U.S. UTILITY Patent Application

APPLICATION NO. 09/540610	CONT/PRIOR	CLASS 438 257	SUBCLASS 774 4	ART UNIT 2812 2815	EXAMINER <i>Chw</i>
------------------------------	------------	------------------	-------------------	-----------------------	------------------------

Method for eliminating lateral spacer erosion on enclosed contact topographies during RF sputter cleaning

FIGURE 1
(Prior Art)

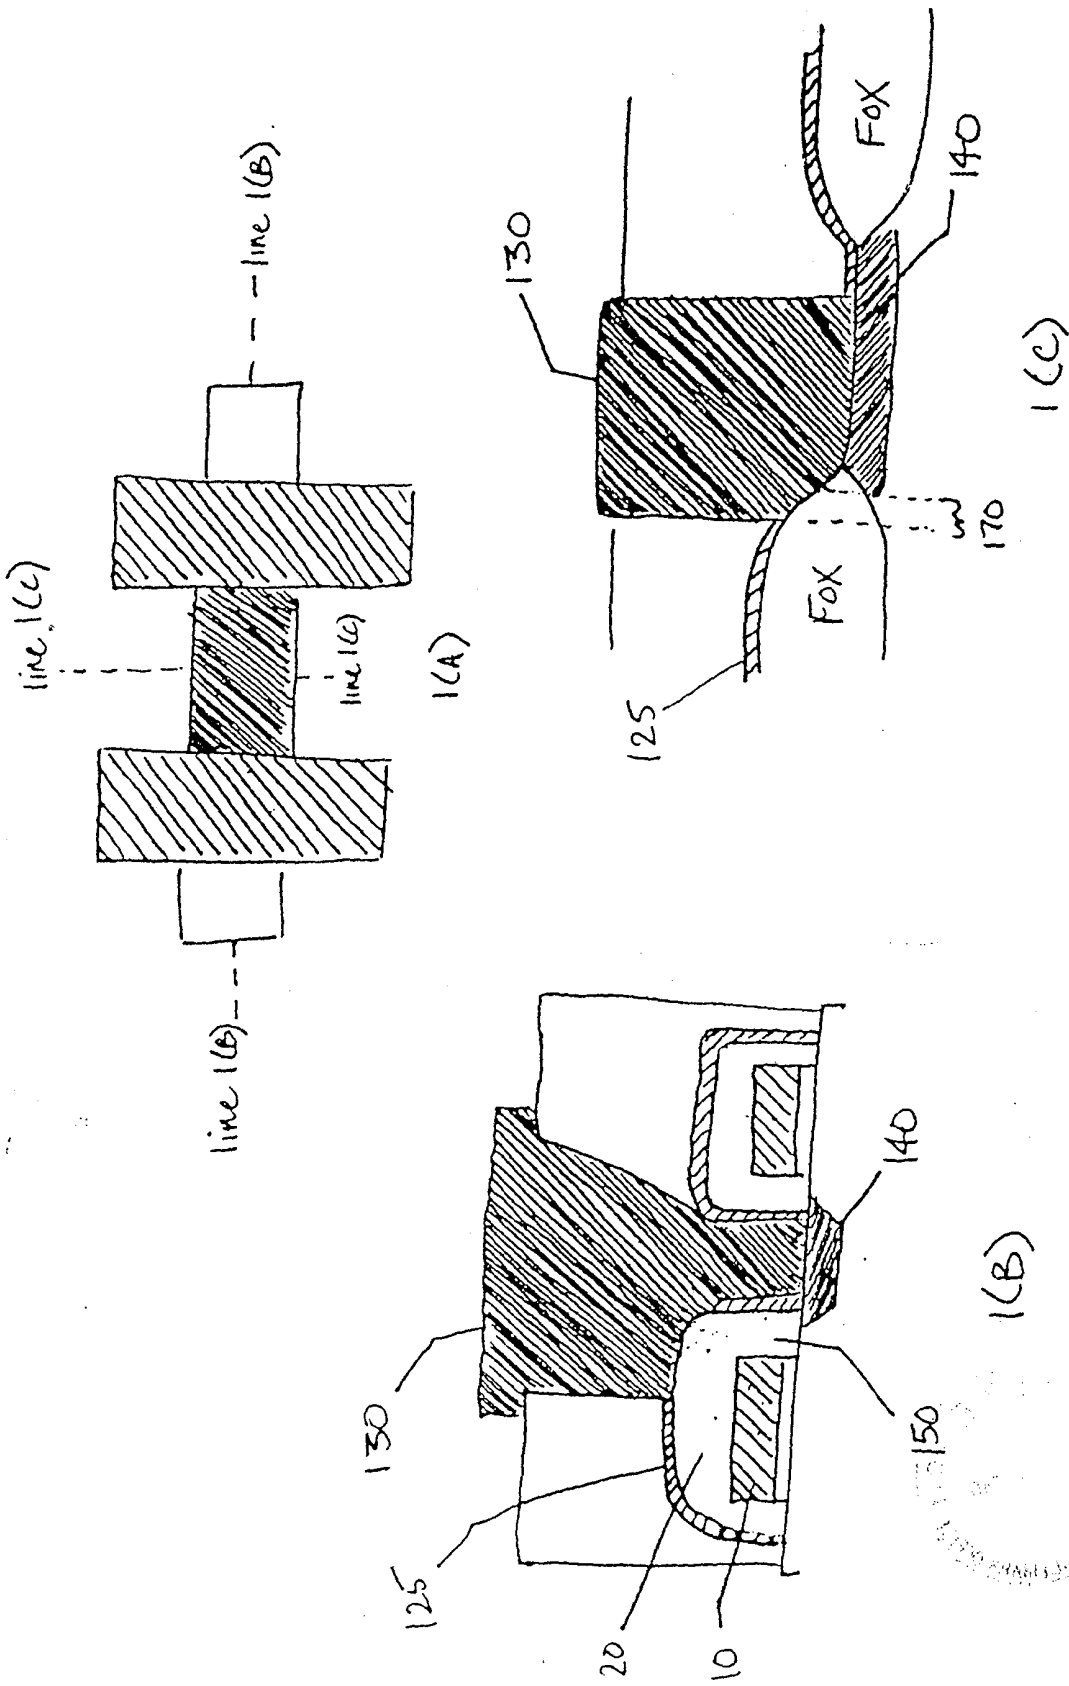
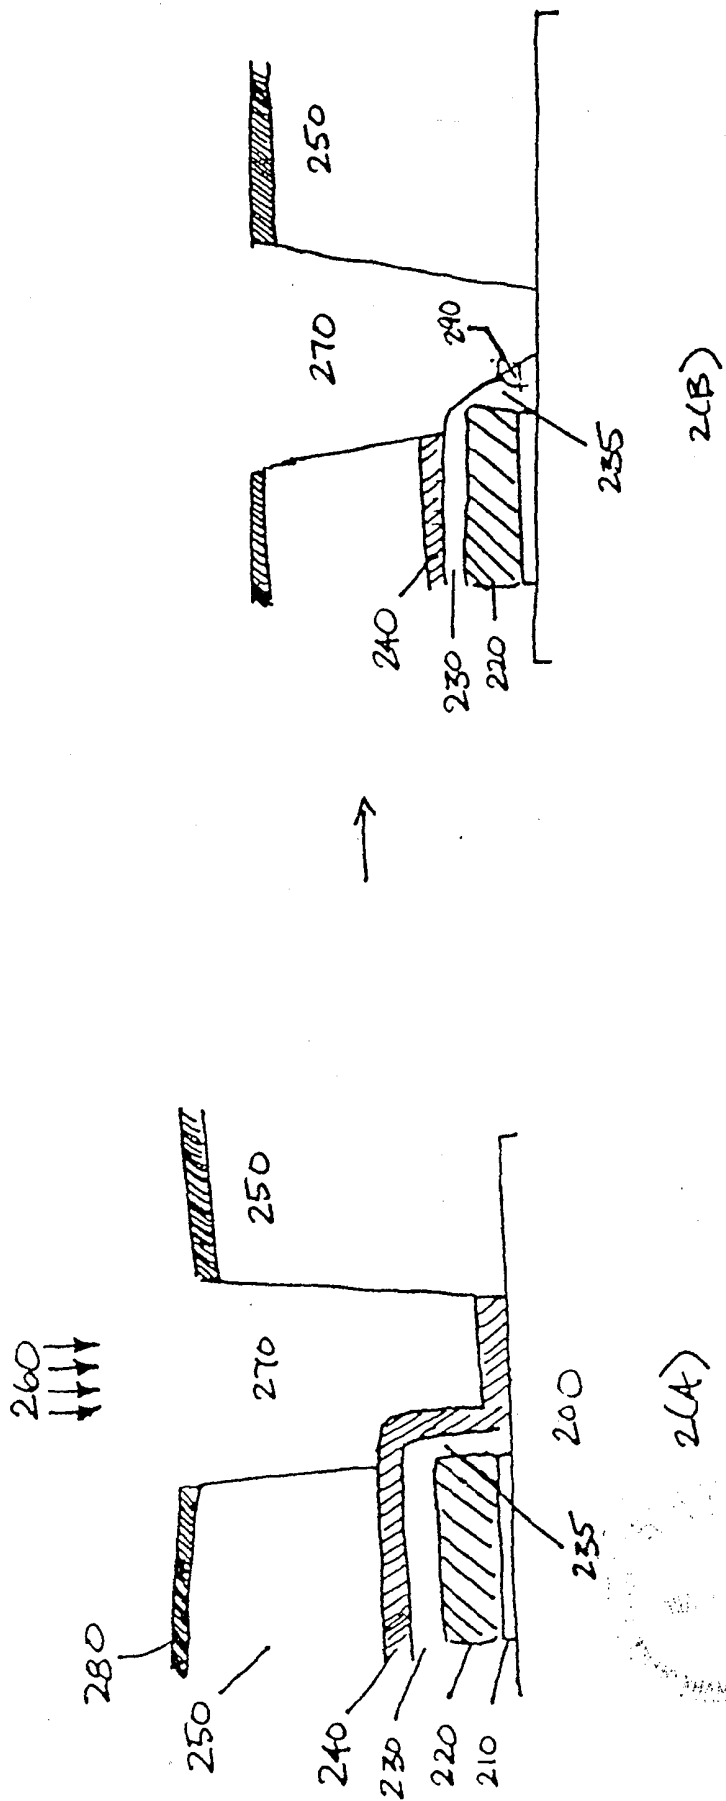
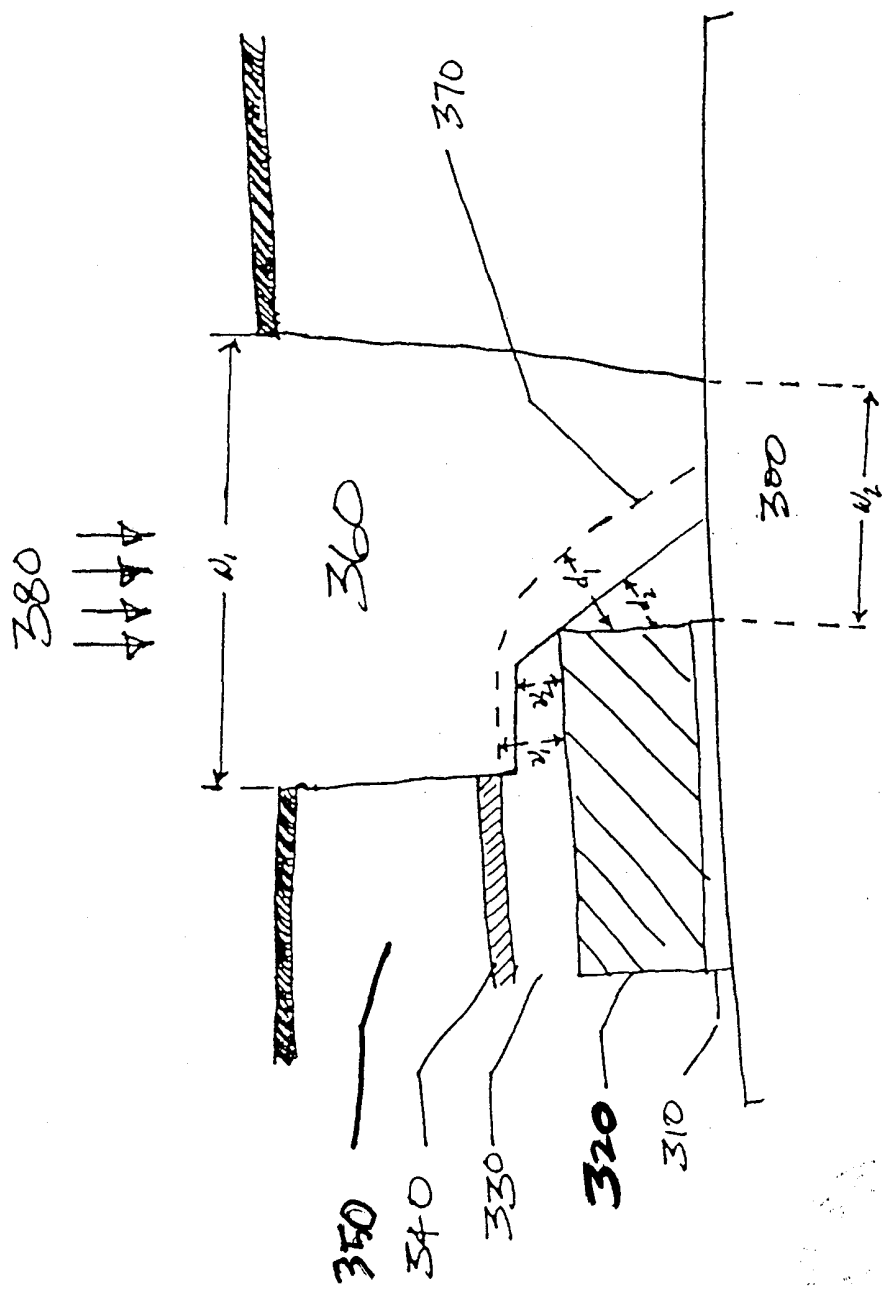
3. Figures 1 ~ 3 should be designated by a legend such as --Prior Art-- because only that which is old is illustrated. See MPEP § 608.02(g).
4. The drawings are objected to under 37 CFR 1.83(a). The drawings must show every feature of the invention specified in the claims. Therefore, the contact region in the first insulating layer must be shown or the feature(s) canceled from the claim(s). No new matter should be entered.
5. The drawings are objected to as failing to comply with 37 CFR 1.84(p)(5) because they include the following reference sign(s) not mentioned in the description: reference number "455" in Fig. 4H is not disclosed in the specification. Correction is required.

On page 16, lines 14 ~ 18, there are two brief descriptions for Figure 3. Which brief description is the brief description of Figure 3?

The specification has been amended to delete the second description of Figure 3 in the brief description of the drawings on pg. 16, ln. 15-16.

Fig. 4(H)

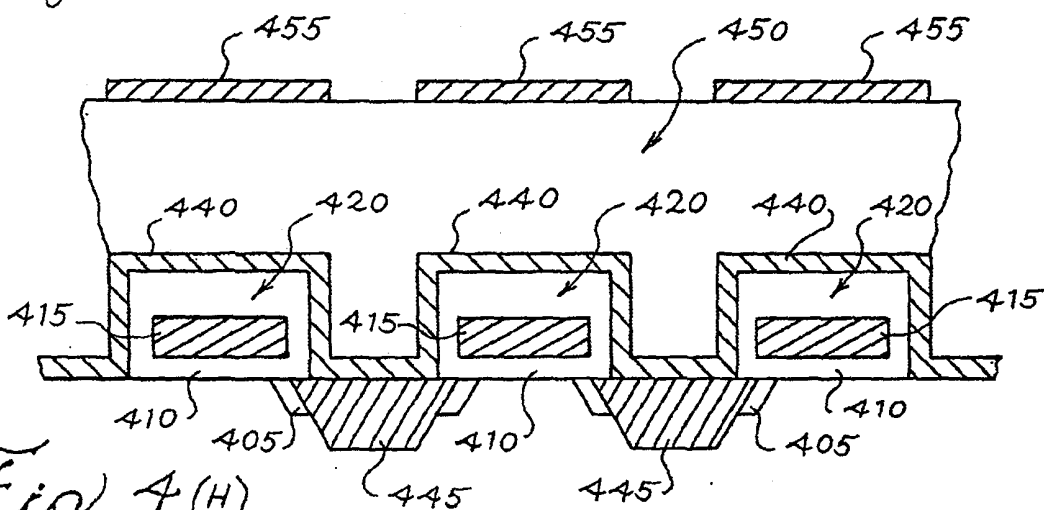
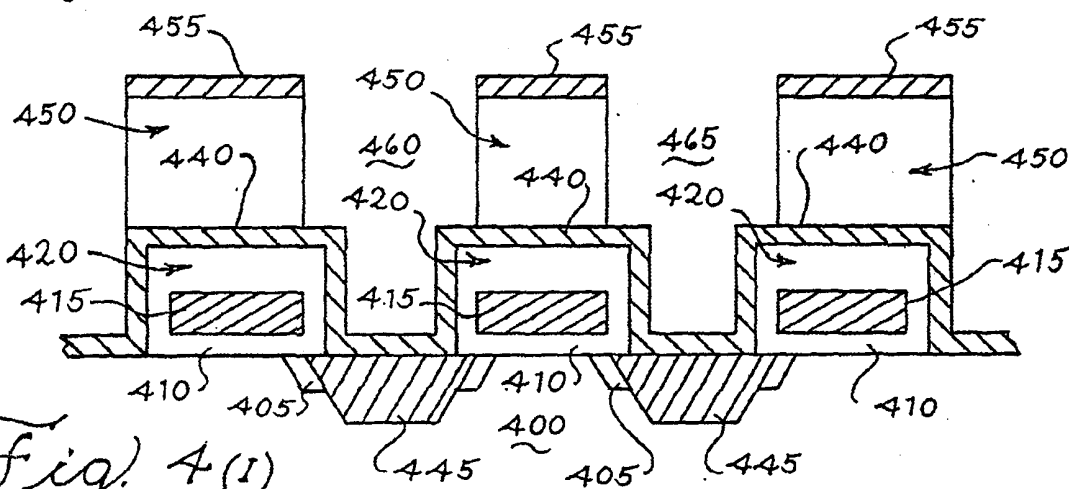
On pages 24, line 3, "Figure 4(H)" should be --Figure 4(I)--. This is because, the various reference characters they designate to Figure 4(H) on the page 24 of the specification appear to be inaccurate. Base on the description, i.e., reference characters 450, 460, etc., it appears that applicant is describing Figure 4(I). Therefore, the reference to Figure 4(H) should be changed to Figure 4(I).

The disclosure is missing a detailed description of Figure 4(H).

Applicants note that the detailed description of Figure 4(H) is found on pg. 24, ln. 3-6. The detailed description of Figure 4(I) is found on pg. 24, ln. 6-8. Reference to Figure 4(I) has been added. Withdrawal of the objection to the specification on these grounds is respectfully requested.
